WILLIAMSON COUNTY, TEXAS

CHANGE ORDER NUMBER: 6

Project: SE LOOP S1 P1

Change Order No. 6

DESIGNED:	PROJECT NUMBER		ROADWAY	
CHECKED:			SE LOOP	
DRAWN:	STATE	COUNTY	CITY	SHEET No.
CHECKED:	TEXAS	WILLIAMSON		15A

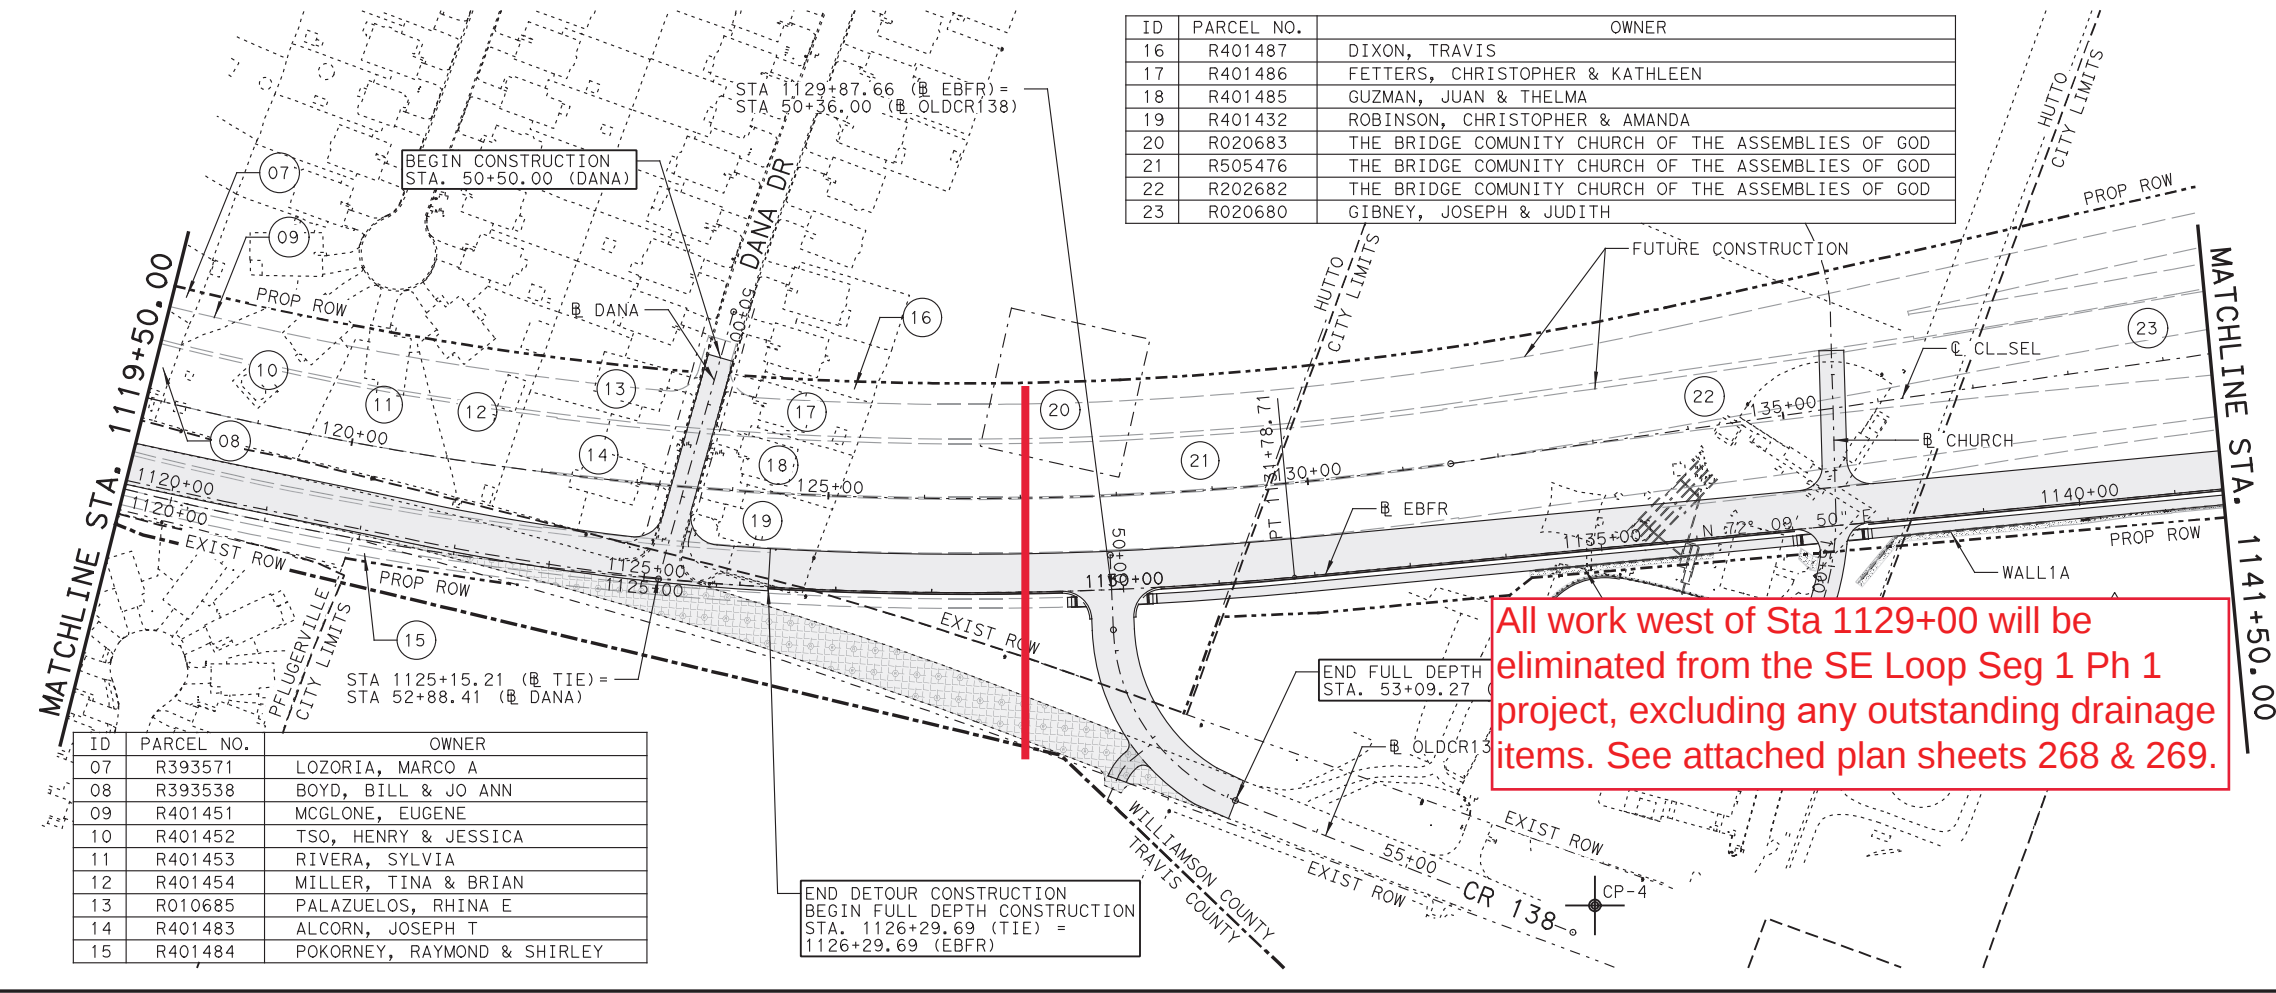
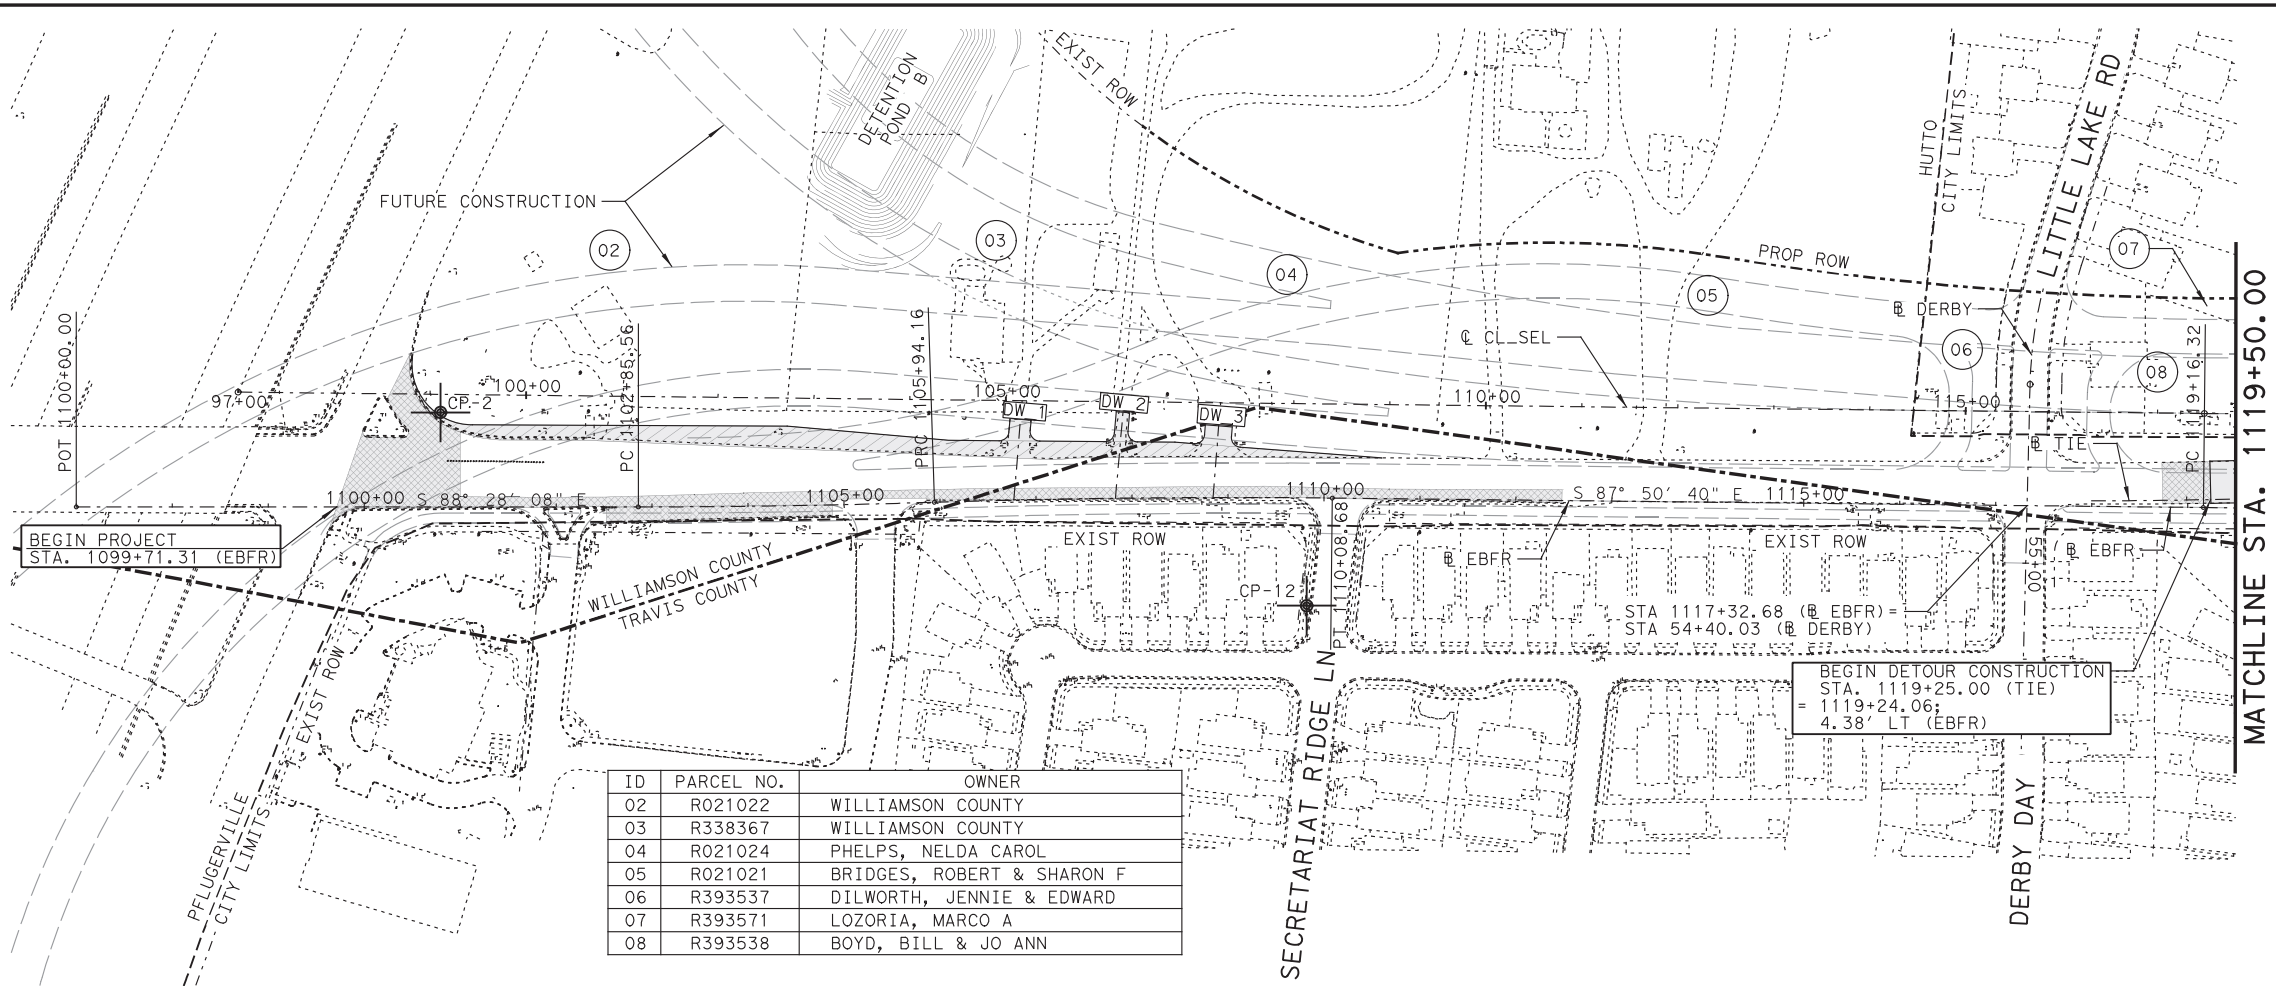
Qty's from previous sheet.
30,354 & 57,265

Totals including previous sheet.

Revised earthwork
qty's, per RFI #16 and
Change Order #5.

SE LOOP SEGMENT 1 PHASE 1 PROJECT LAYOUT

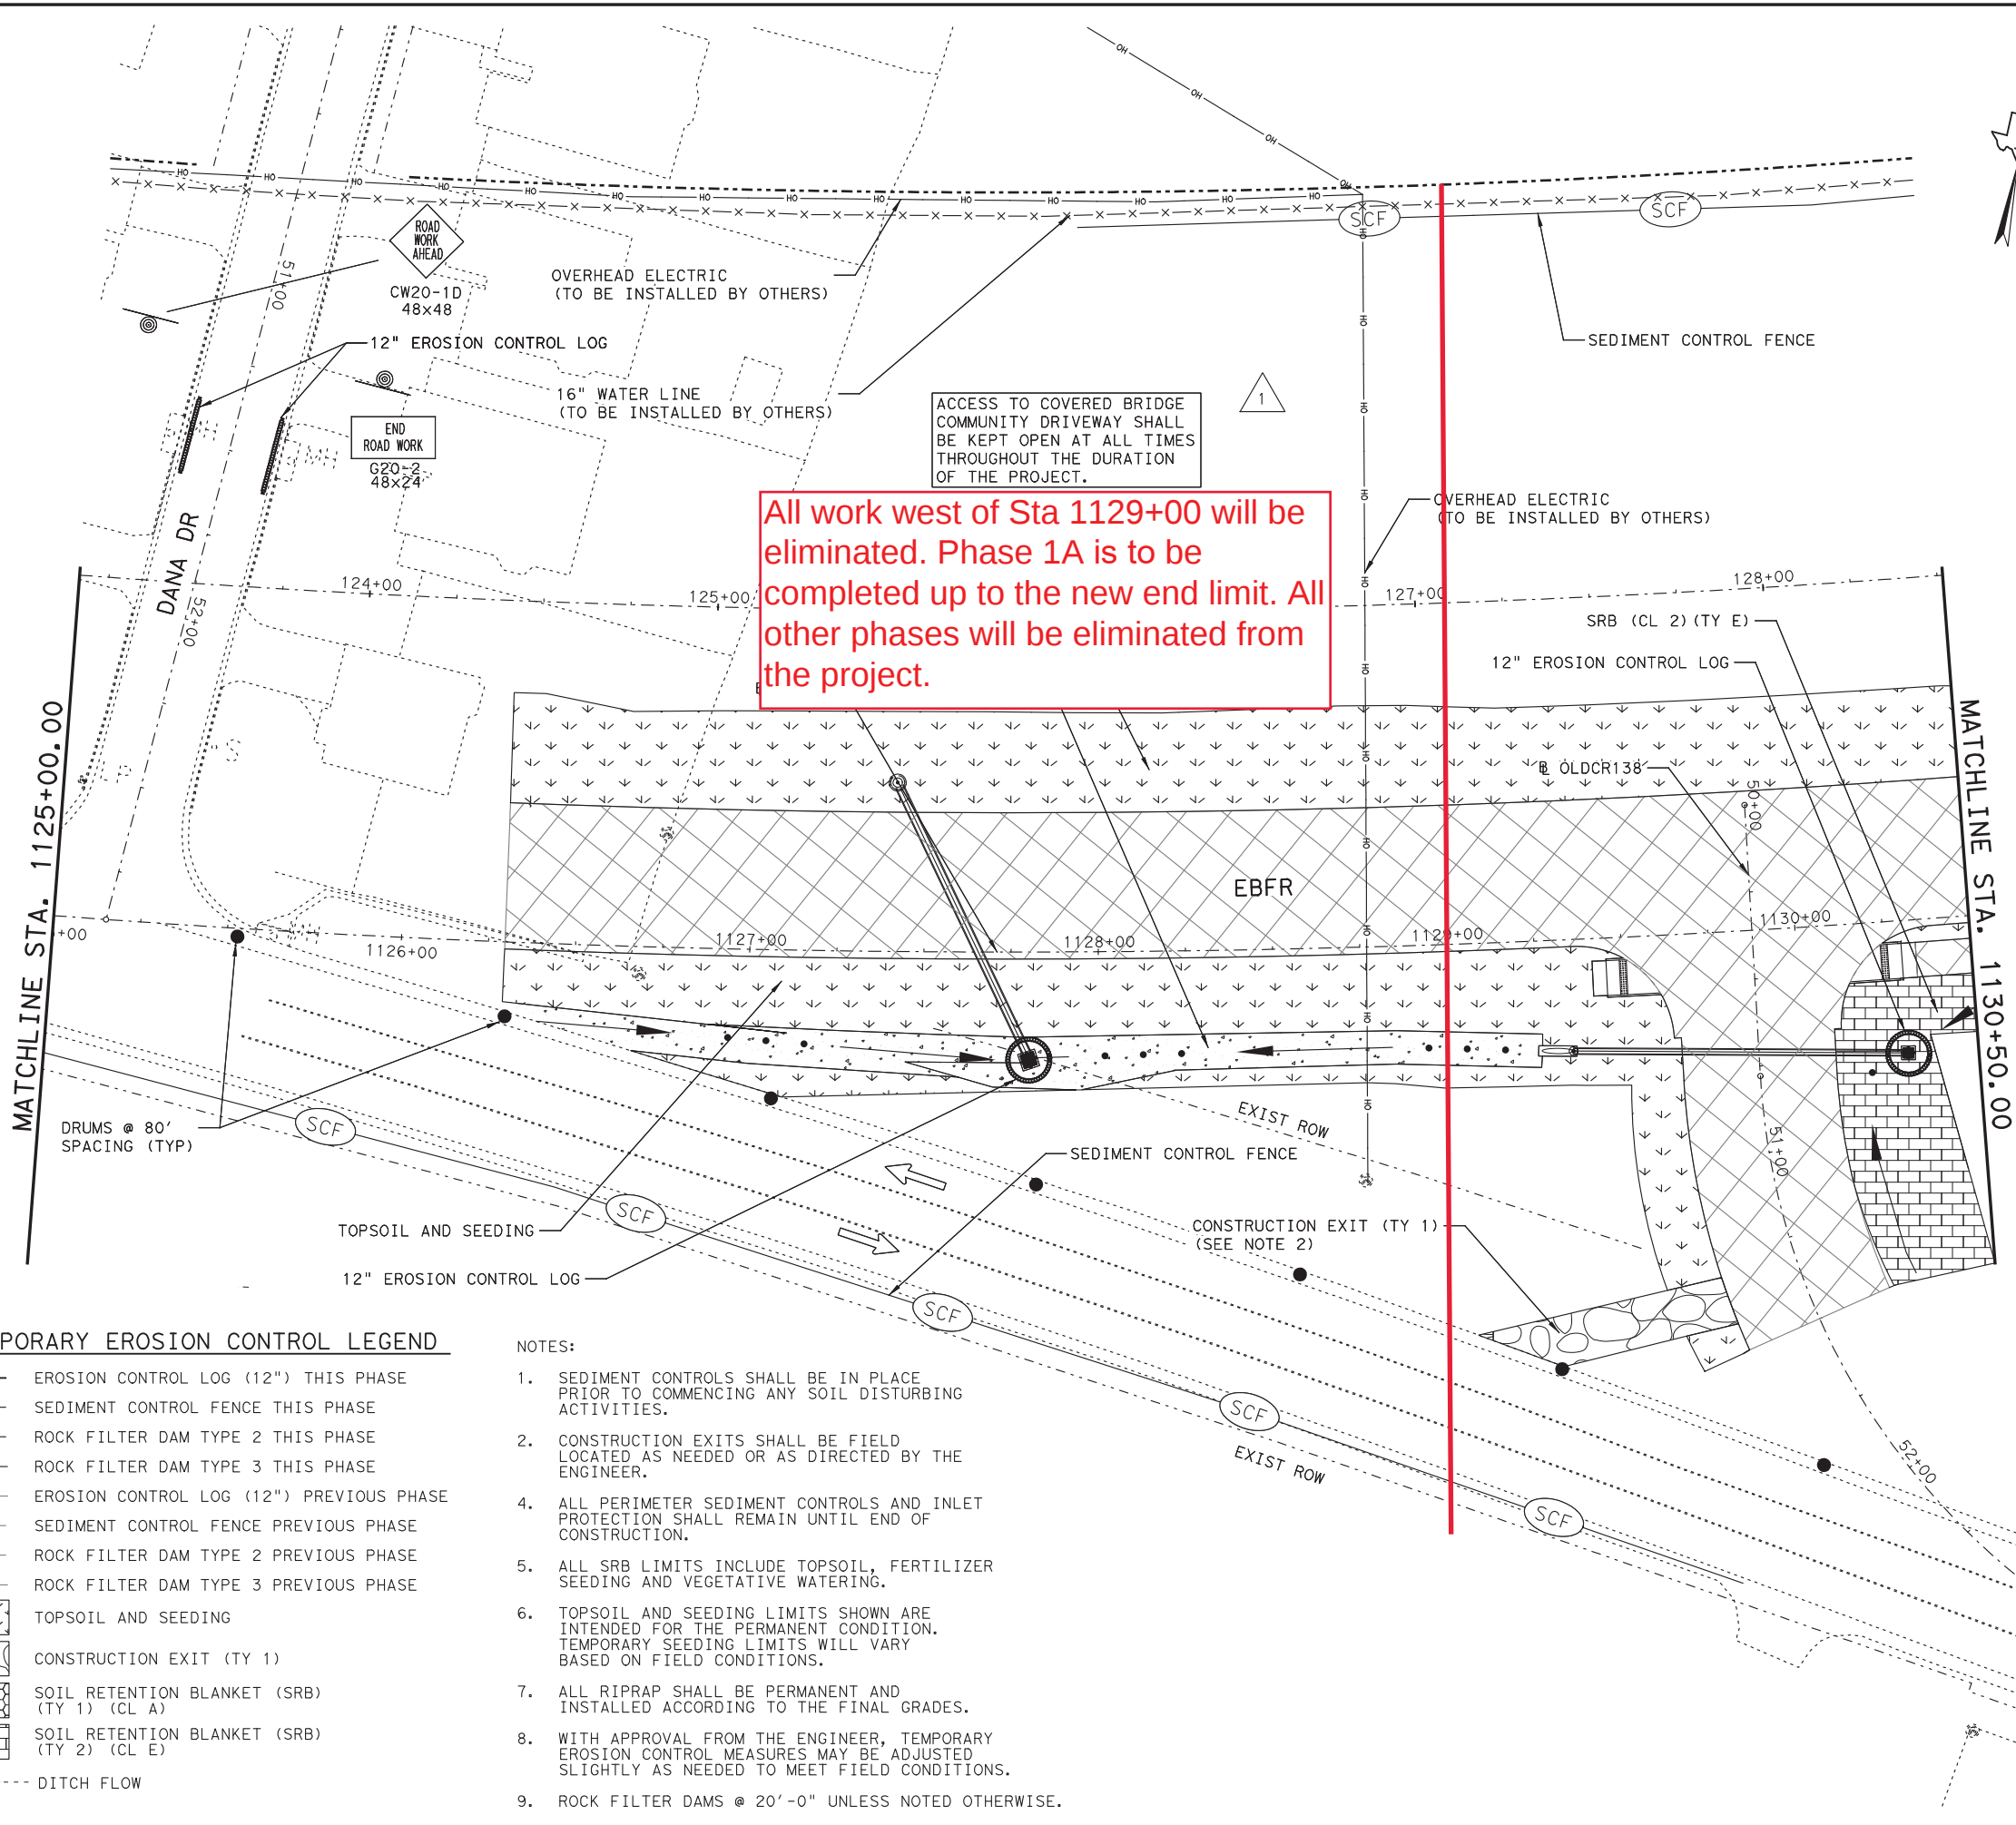
All work west of Sta 1129+00 will be eliminated. Phase 1A is to be completed up to the new end limit. All other phases will be eliminated from the project.
